## Council Action and Executive Summary

Item # 16Ordinance/Resolution# 11-012Council District: 5For Meeting of July 6, 2010

**TITLE:** A RESOLUTION APPROVING A DEVIATION TO CHAPTER 32 OF THE LAS CRUCES MUNICIPAL CODE (DESIGN STANDARDS) FOR (1) AN ALTERNATE CROSS-SECTION FOR PUBLIC RIGHT-OF-WAY IMPROVEMENTS TO A SEGMENT OF SONOMA RANCH BOULEVARD FROM PEACHTREE HILLS ROAD NORTH TO ARROYO ROAD; (2) A DELAY IN PUBLIC RIGHT-OF-WAY IMPROVEMENTS TO A SEGMENT OF ARROYO ROAD FROM THE INTERSECTION OF SONOMA RANCH BOULEVARD WEST TO THE ENTRANCE OF A PRIVATE GOLF COURSE; (3) A NUMERICAL DEVIATION OF 26-FEET FROM THE REQUIRED 50-FEET FOR A PERMANENT PRIVATE ROAD AND/OR ACCESS EASEMENT KNOWN AS SIERRA DE LUNA FROM THURMOND ROAD NORTH TO THE ENTRANCE OF A PRIVATE GOLF COURSE FOR THE PURPOSE OF ACCESS TO A COMMERCIAL DEVELOPMENT FROM A PUBLIC ROADWAY (THURMOND ROAD); AND (4) A DEVIATION TO THE MINIMUM STANDARDS OF A MINOR LOCAL ROADWAY FOR THE PURPOSES OF MINIMUM ACCESS IMPROVEMENT REQUIREMENTS TO A ROADWAY SEGMENT KNOWN AS SIERRA DE LUNA. SUBMITTED BY SIERRA NORTE LAND HOLDINGS, INC.

**TYPICAL SONOMA RANCH BOULEVARD CROSS SECTION  
NORTH OF PEACHTREE AND SOUTH OF ARROYO**

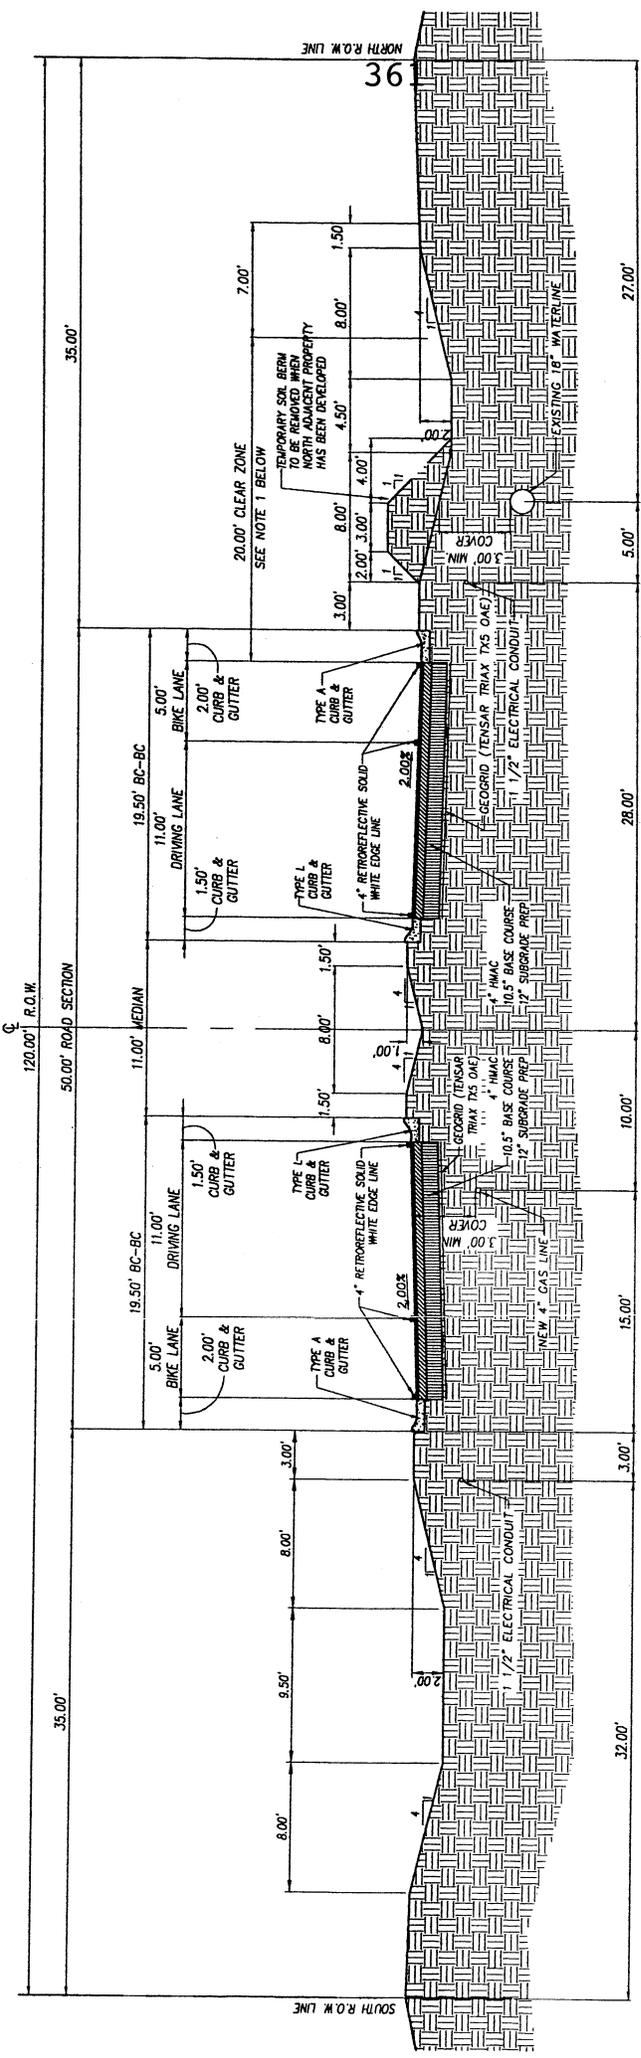
We would like your help in obtaining approvals to continue Sonoma Ranch Blvd. from Peachtree Hills Road to Arroyo Road, as well as Arroyo Road from Sonoma Ranch Blvd. to the new golf course. We are requesting clarification of several related issues as well.

We recently prepared a set of drawings for eventual construction of a full cross-section for Sonoma Ranch Blvd., and we would like to utilize that work where possible. We've previously discussed with you the advantages of having the design approved for the full cross-section even though less than the full cross-section will be built initially. The first advantage is that any party obligated to contribute part of the construction at a later date will know exactly what is required. The second advantage is that the portion of the road that is built now will conform to a part of the full cross-section, thus eliminating the possibility of wasting what is being built now.

**TYPICAL SONOMA RANCH BOULEVARD CROSS SECTION**  
**SOUTH OF AFROYO RD. AND NORTH OF THURMOND**  
 SCALE: NTS

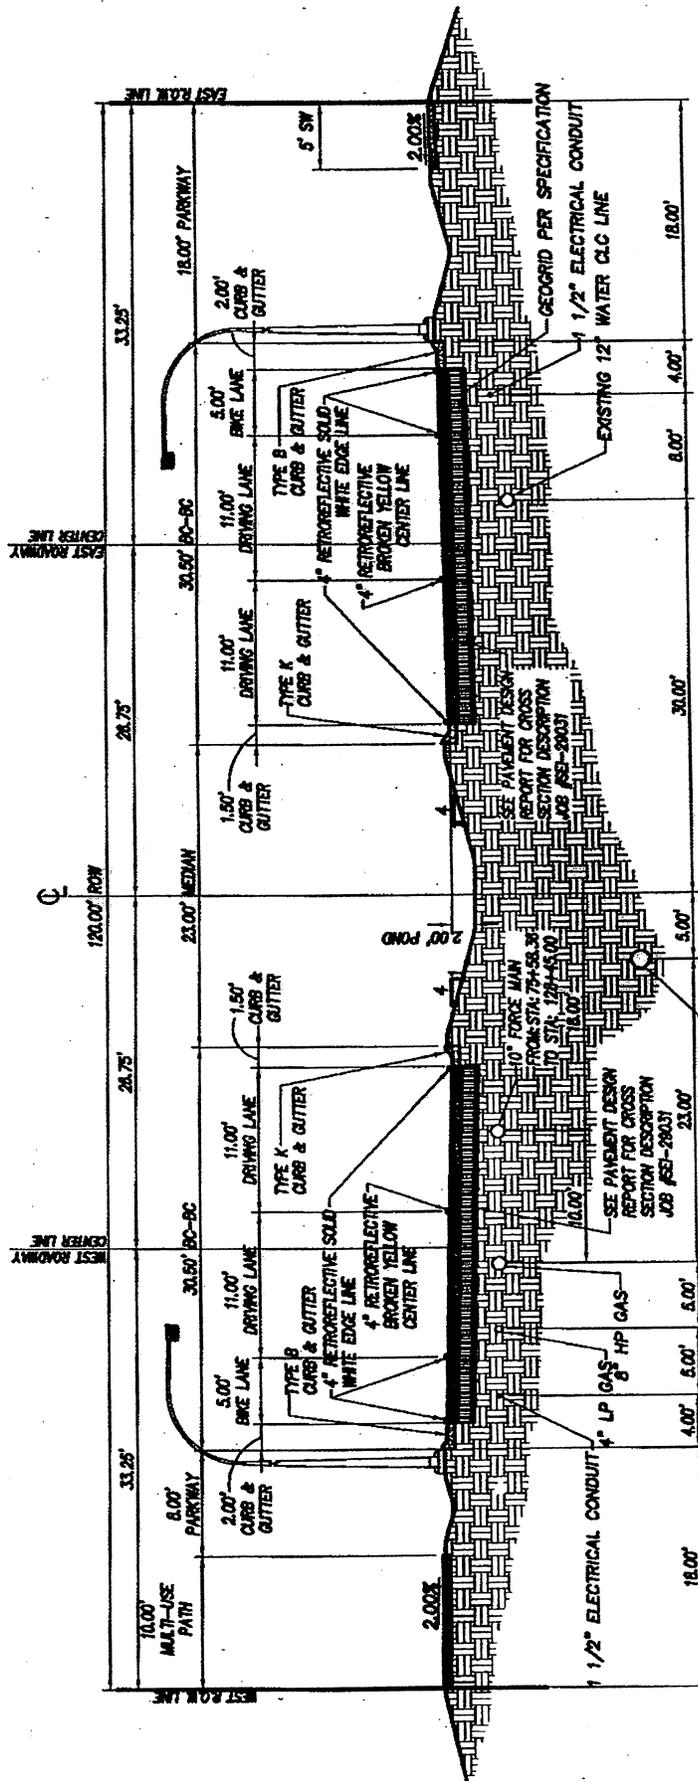
- 1 the intersection of Arroyo Road as part of this amendment process but  
 2 my question is for Sonoma Ranch in a much broader scope is, is there  
 3 plans to keep that, to seek permission to keep that cross section that's  
 4 been approved with the original Metro Verde to take that cross section  
 5 all the way down south to tie into another thoroughfare like Peachtree  
 6 Hills or even Engler or... what's the long range plan for Sonoma Ranch?  
 7
